HOWARD COUNTY HISTORIC PRESERVATION COMMISSION

June Agenda

Thursday, June 1, 2017; 7:00 p.m.

Figure 5 - Location of gas meter

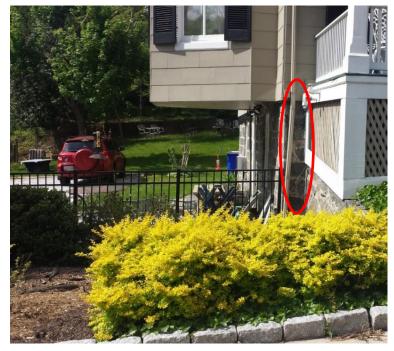
The placement of the gas meter complies with Chapter 6.M recommendations for the placement of equipment and hardware, "use landscaping or low fencing to screen ground level equipment placed in a location visible from a public way or neighboring property." The gas meter will be located on the west side of the front of the house, by a drain pipe running down in the corner, behind the shrubs, as indicated in Figure 5.

Figure 14 - Pergola truss birds eye view

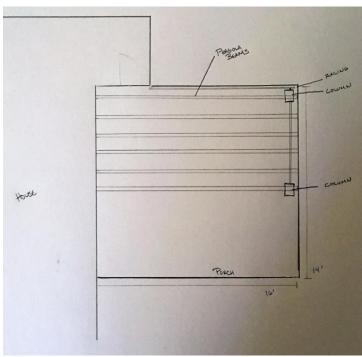
The proposed white railings and columns that would match those on the historic porch do comply with the Guidelines. However, the proposed pressure treated lumber deck does not comply with the Guidelines. Chapter 7.C recommends, "on historic buildings, construct porches of painted wood rather than poured concrete, metal or unpainted wood. Use stained or unpainted wood only for less visible features of a new porch, such as the decking or step treads on the rear of a building in a location not facing or highly visible from a public way." The proposed deck will be highly visible from the public right of way and pressure treated lumber is not appropriate. Moreover, painting the proposed deck to simply comply with the Guideline is not appropriate either because it will still read as a deck tacked on to a prominent side of the house, rather than a carefully designed, historically and architecturally compatible addition.

Staff Recommendation: Staff recommends the Applicant withdraw the current application and submit a new proposal for a stone patio or a lower deck that is in keeping with the Ellicott City Design Guidelines. Otherwise, Staff recommends Denial of the application as submitted, in which case the Applicant cannot return for one year for the same or similar design.
